D E S I G N
R E V I E W
C O M M I T T E E
S T A F F R E P O R T

2127 DWIGHT WAY

FINAL DESIGN REVIEW

Design Review #DRCF2024-0002 to demolish two of the existing four residential buildings (demolish eight units and retain eight units) and replace with a new six-story residential building featuring 58 new units, for a combined total of 66 residential units.

A3.00D

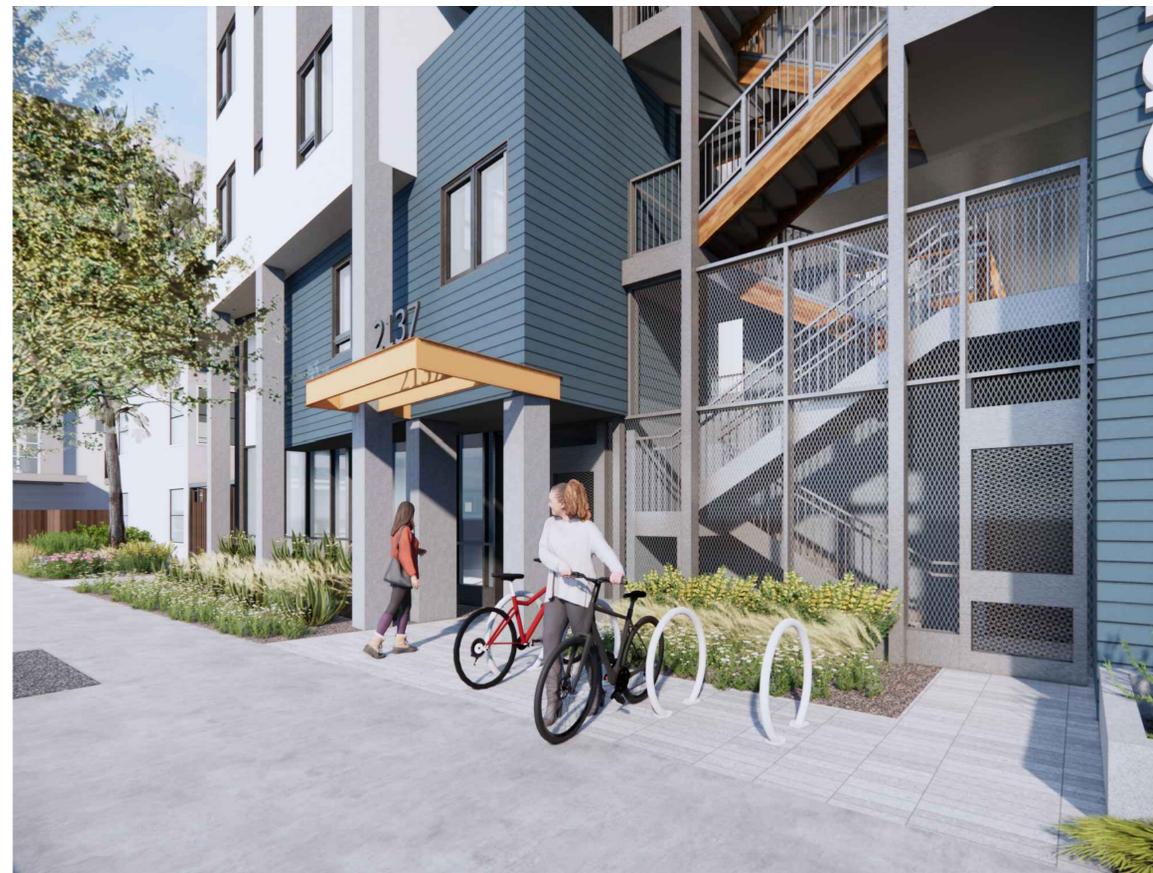
- Plans, elevations, sections, and renderings;
 - Dwight Street facades have been further developed per Committee comments, including a more defined lobby entrance and a more decorative security gate.
- Construction details, wall and window sections; and
- Landscape plans, plant palette and roof deck details.
 - Streetscape and courtyard design have been revised. See Sheet A3.00D.
